Talk re stormwater problems in areas near
NDMA05 + NDMA10 8/13/2021

URBAN CAPABILITY MAP FOR PROPOSED SUBDIVISION- DALZIEL ROAD.

From: Z1649206 MWH Hazards Team <SM-AP-NZ-MWHHazardsTeam@mwhglobal.com>
Sent: Monday, 18 January 2016 02:01 p.m.
To: Lianne Darby
Subject: RE: Subdivision at Dalziel Road - The Sequel - SUB-2015-54 & LUC-2015-291
35, 41, 43, 47 & 49 Dalzeil Rd, Dunedin

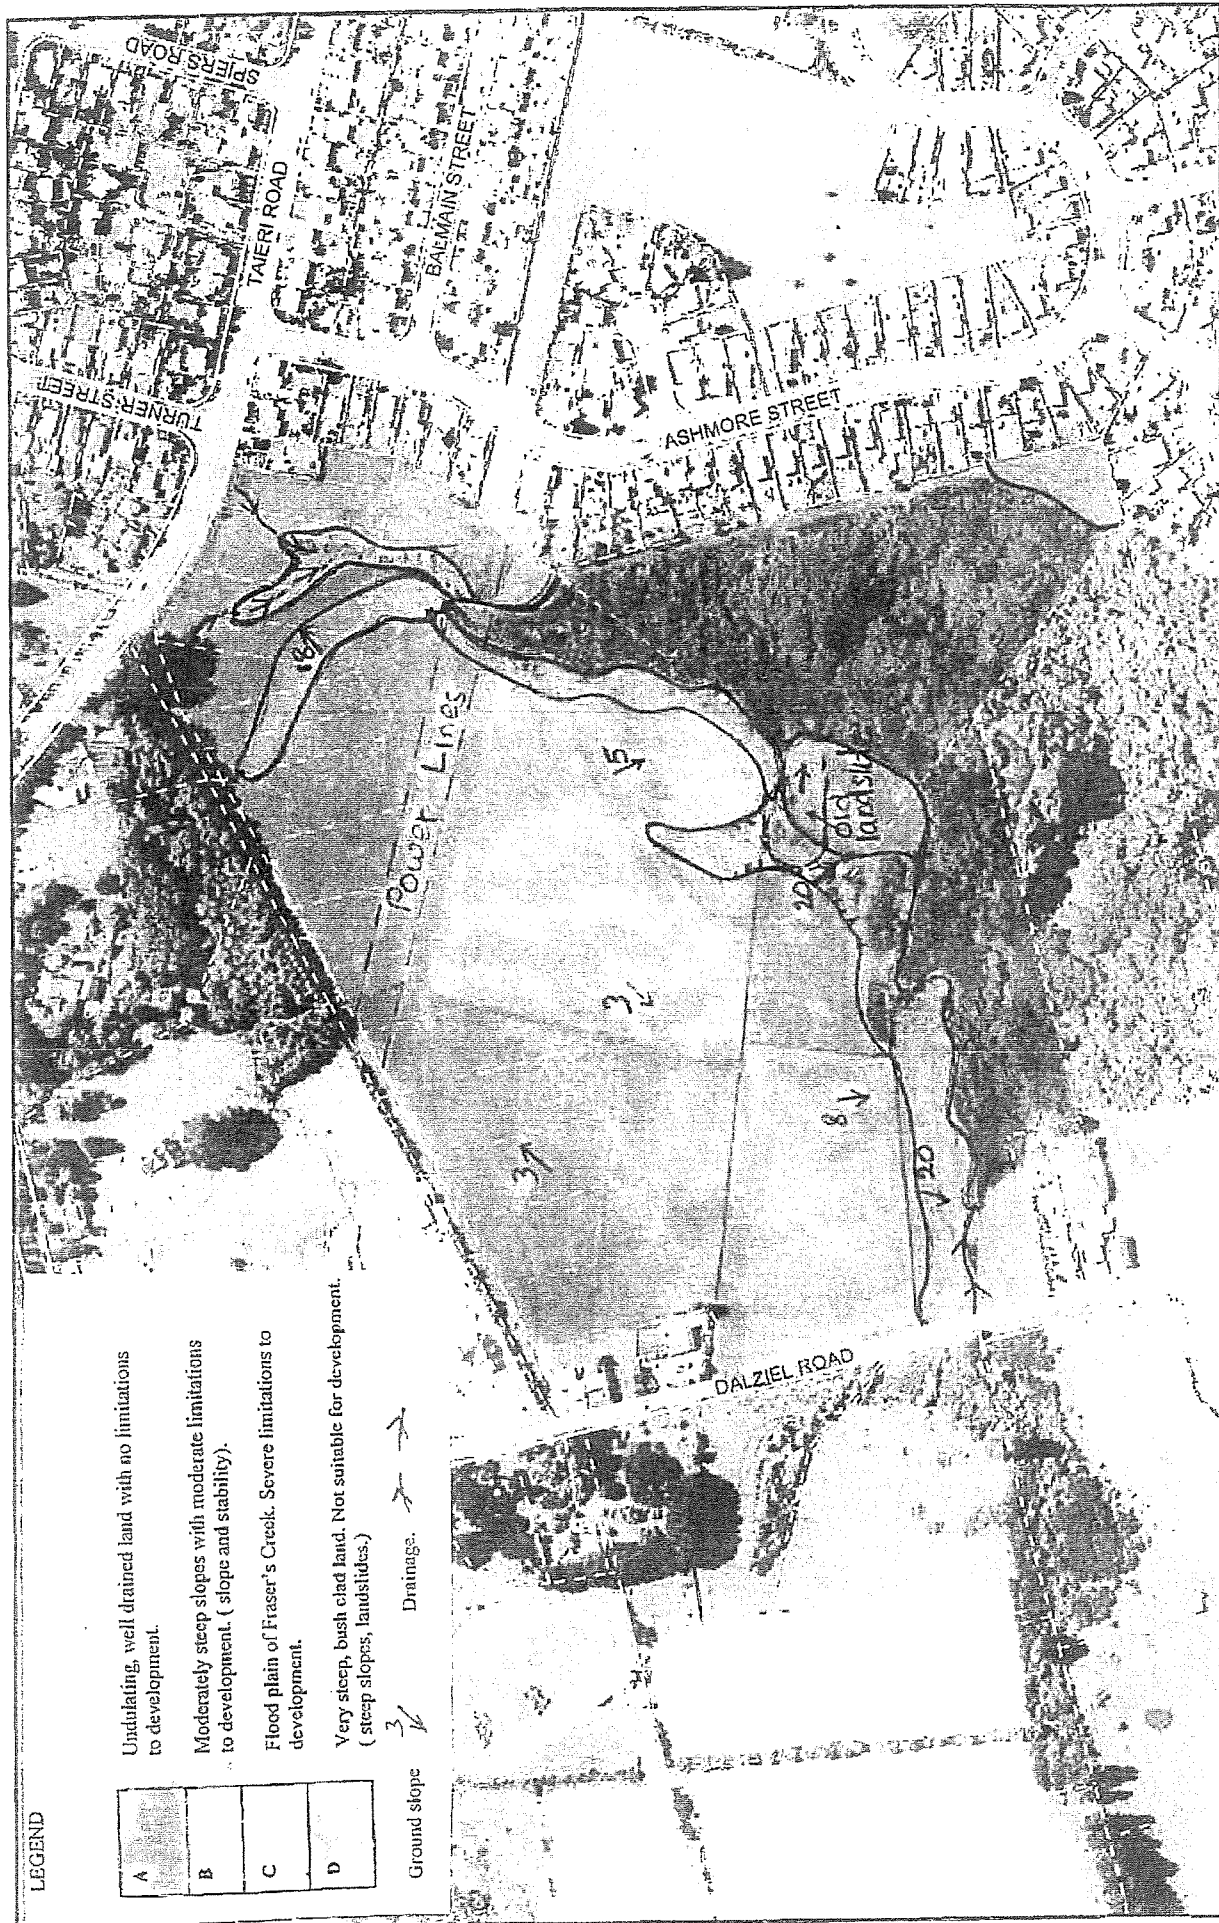
Note Swale drains ~~at~~ the side of Dalziel Rd don't contain continuous rain successfully. At the bottom left-hand corner of NDMA05 there has been

a landslip. This fact is documented on maps. See ref. Appendix B Council Officers Report Feb 2016. Has currently been disregarded since last reported on, and there have been many serious rain events since then. Put houses and concrete above it and that could cause further instability. My comment Another event such as Abbotsford could occur. Alice will speak further on this area and damage caused to walking tracks and flooding in Kaituma Valley.
